UNITED STATES PATENT AND TRADEMARK OFFICE

APPLICATION NO.	FILING DATE	FIRST NAMED INVENTOR	ATTORNEY DOCKET NO.	CONFIRMATION NO.
10/605,623	10/14/2003	Julian B. Melendrez	ZIGP102US	2622
24041 7590 06/19/2007 SIMPSON & SIMPSON, PLLC 5555 MAIN STREET WILLIAMSVILLE, NY 14221-5406			EXAMINER MCAHON, MARGUERITE J	
			ART UNIT 3747	PAPER NUMBER
			MAIL DATE 06/19/2007	DELIVERY MODE PAPER

Office Action Summary

DETAILED ACTION

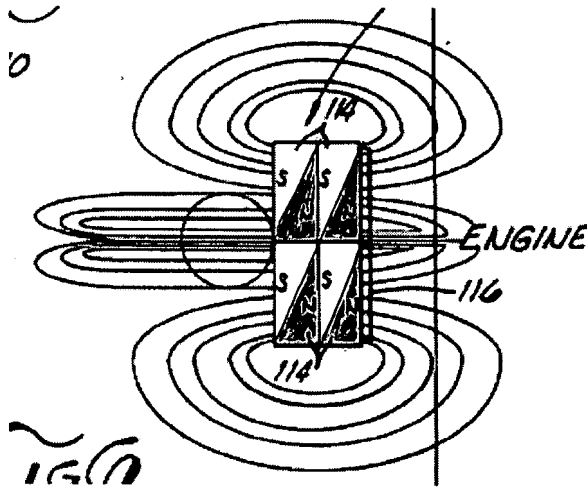
Applicant has attacked the viability of the Ettehadieh reference by claiming that the magnets are configured such that like polarities are in direct contact with each other. This argument is based on an assumption that the divisions between the poles is parallel to the long sides of the magnets, as shown in the Figure drawn by Applicant in the Appendix to the Remarks/Arguments. If this assumption were correct, Ettehadieh would have problems, as suggested by Applicant. However, this assumption is not supported by any solid evidence in the Ettehadieh reference. The manner in which the poles are shown in the Figures of the Ettehadieh reference and particularly the manner

in which the flux lines of force are drawn in the Ettehadieh reference suggests that a different assumption is more likely to be true, as shown below:

The Figure (Figure 6 of Ettehadieh) shows the poles such that the north poles are shaded (by the examiner to indicate the examiner's assumption about polarity division) and the south poles are left white. This kind of division between the poles can be assumed by the manner in which the poles are referenced and is consistent with the lines of flux shown emanating from the magnets, and allows the magnets to function without the problems obtained when assuming that the poles are divided by lines parallel to the long side of the magnets (i.e. vertical, in the case of Figure 6), as Applicant has. Since Ettehadieh is silent as to exactly the manner in which the poles are delineated, it makes sense to the examiner to make the assumption which would allow the device of Ettehadieh to be operable, rather than to assume that Ettehadieh would configure the polarity of the magnets, such that the device would be inoperable.
